WILLIAM BERRY & SON, INC.  
 REVIEWED IN ACCORDANCE WITH THE CONTRACT DOCUMENTS.  
 THE SUBCONTRACTOR/VENDOR IS RESPONSIBLE FOR ALL DIMENSIONS, CORRECT FIT AND COORDINATION OF ALL ITEMS TO BE FURNISHED & INSTALLED.  
 BY: [Signature] DATE: 7/27/06  
 JOB #: 04-310-0 JOB NAME: 2578-014-2  
 SUBMISSION #: SPEC. REV. REF.  
 REVIEWED FOR CONSTRUCTION

FOR APPROVAL  
 JUL 31 2006

NOVEL IRON WORKS  
 250 Ocean Road  
 Greenland, NH 03840

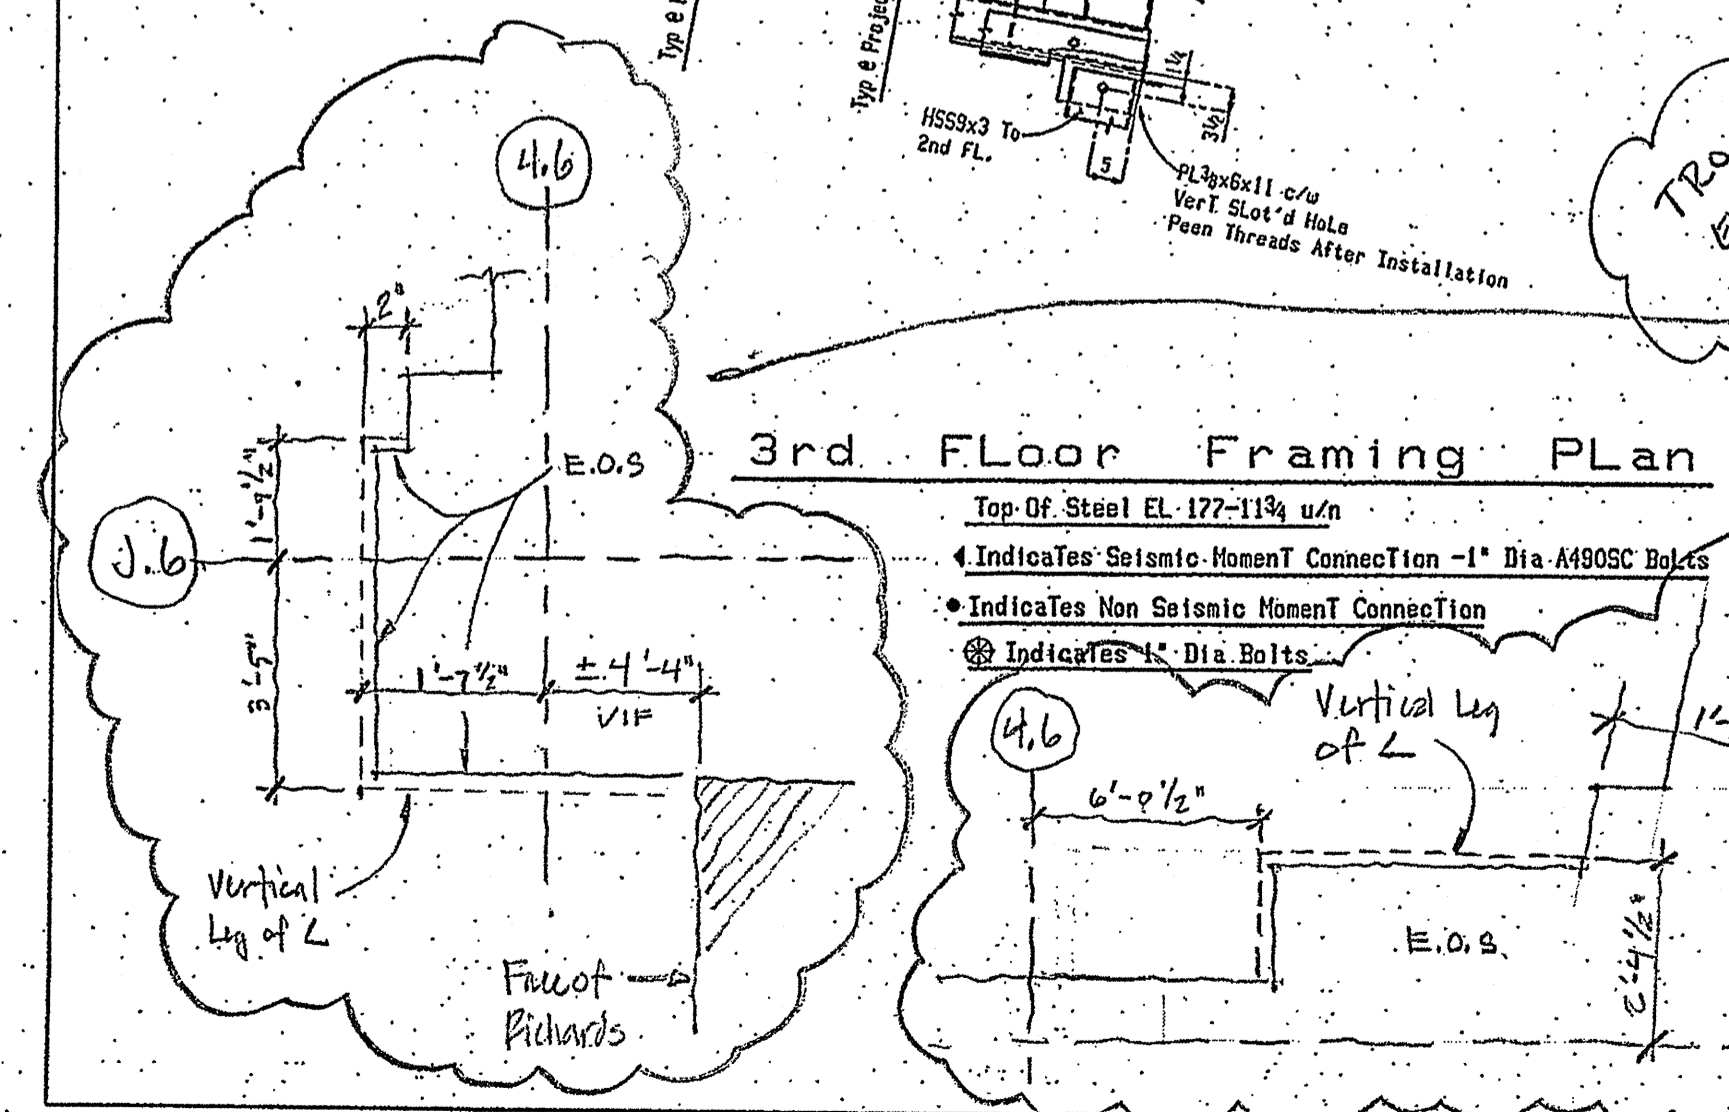
TRC to Review/Verify Extent of Rel. Lx and Revise Memo C10.  
 REL. Lx MUST BE PHASE OF RIBBON.  
 Vertical leg of L  
 Face of Column

Correct the Column  
 Steel Framing (By Others)

TRC to Review/Verify Extent of Rel. Lx and Revise Memo C10.  
 REL. Lx MUST BE PHASE OF RIBBON.

NO CHANGE REQ'D.

NO CHANGE REQ'D.
